TECHNICAL SERVICE BULLETIN

Technical Service Bulletin: 51-1783

TECHNICAL SERVICE BULLETIN 51-1783 REMEDY INSTRUCTIONS

TSB Number:	019-002-2024		
Product:	Cross Brace		
Date:	06/11/2024	Labor Rate:	0.5 Hours

Fig. 1

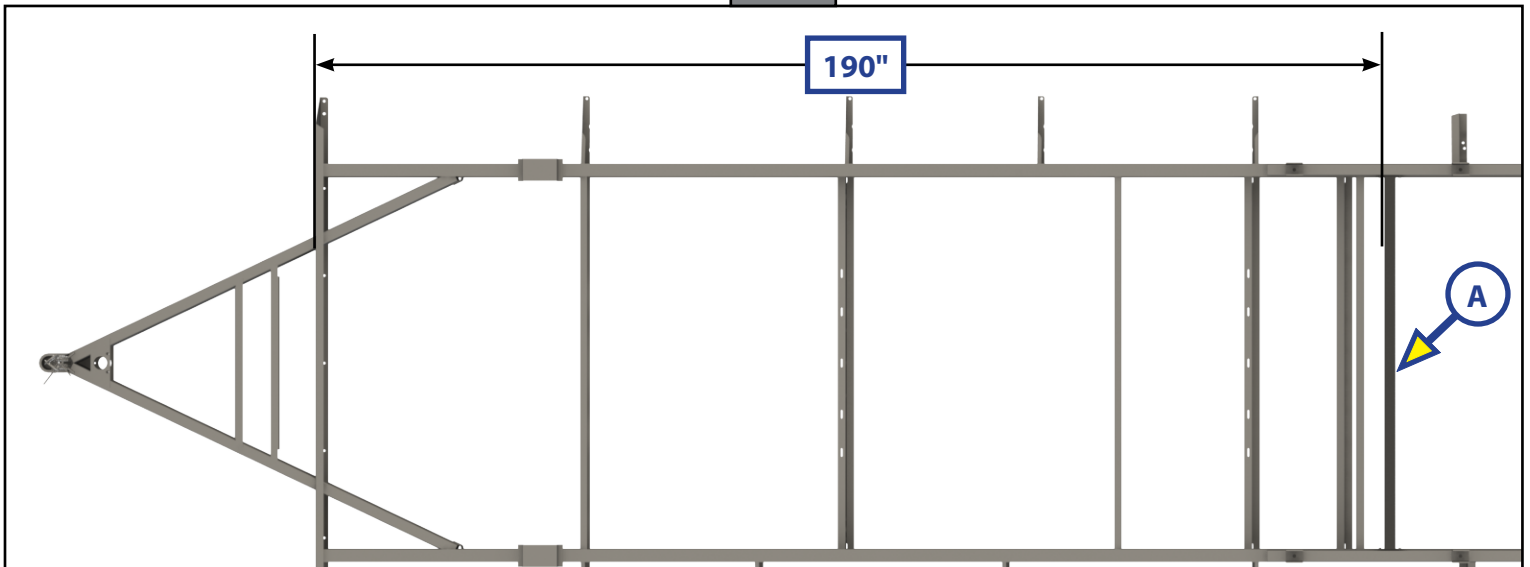
1. Mark the location for the cross brace. The cross brace (Fig. 1A, 2A) is to be mounted 190" behind the front crossmember, and centered vertically on the crush tubes (Fig. 2B).

Fig. 2

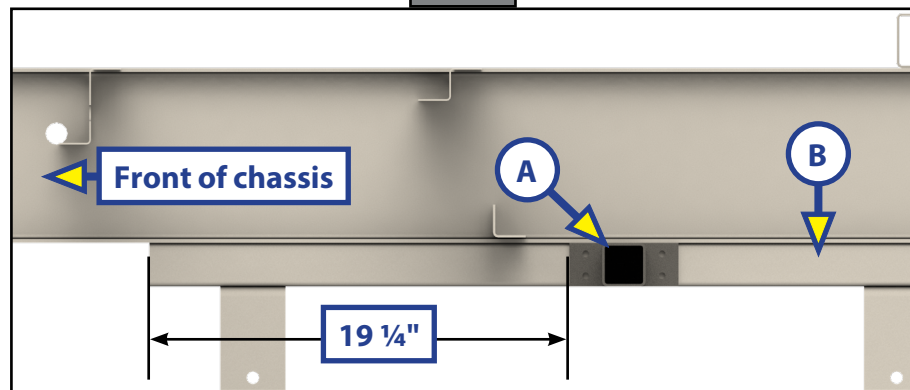
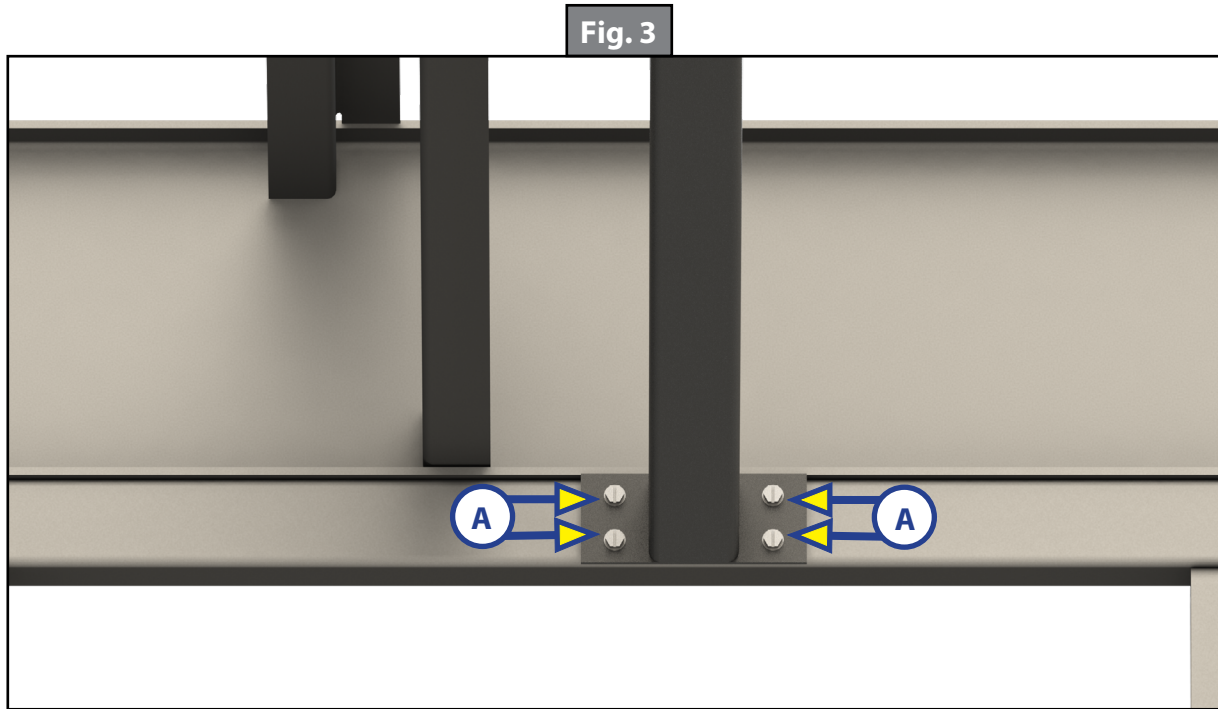
NOTE: The front edges of the cross brace's mounting flanges should be 19 ¼" behind the front edges of the crush tubes (Fig. 2).
